Product hierarchy no. *				Part no.	SBU	Type / Description
SBU	PG	PUG	Type			
01	001	023	0000000351	See list below	Circuit Protection	UMF 250

2 Type of change

Product Change Notification					UMF 250 10A marking		
owner	creation date	release date	released by	change order no	rev	page	D10-046-613
schmidre	22.06.2020	24.06.2020	haeckima	2020169	A	1 of 2

Old product appearance	New product appearance

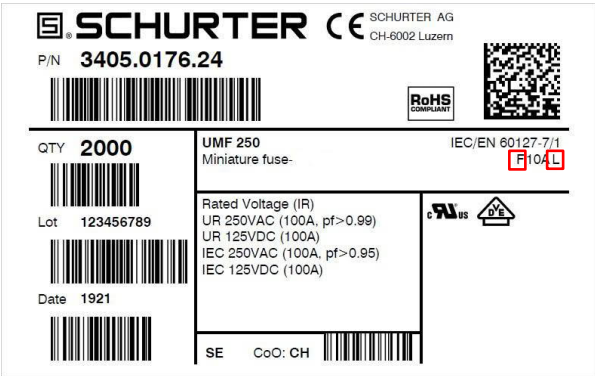
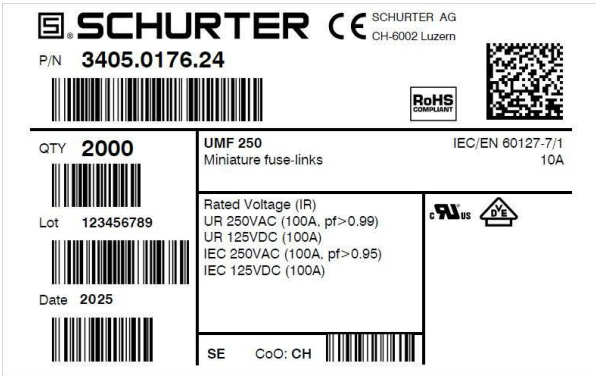
The 10A version got newly approved by VDE on the IEC 60127-7. Since this part 7 doesn't allow to use some reserved characters, we change the product marking and labels accordingly.

The 10A version was originally not approved by VDE. To meet new customer demand, we approved this fuse according to IEC 60127-7.

The change is available from ww 25/2020 (production date code 2025 or higher).
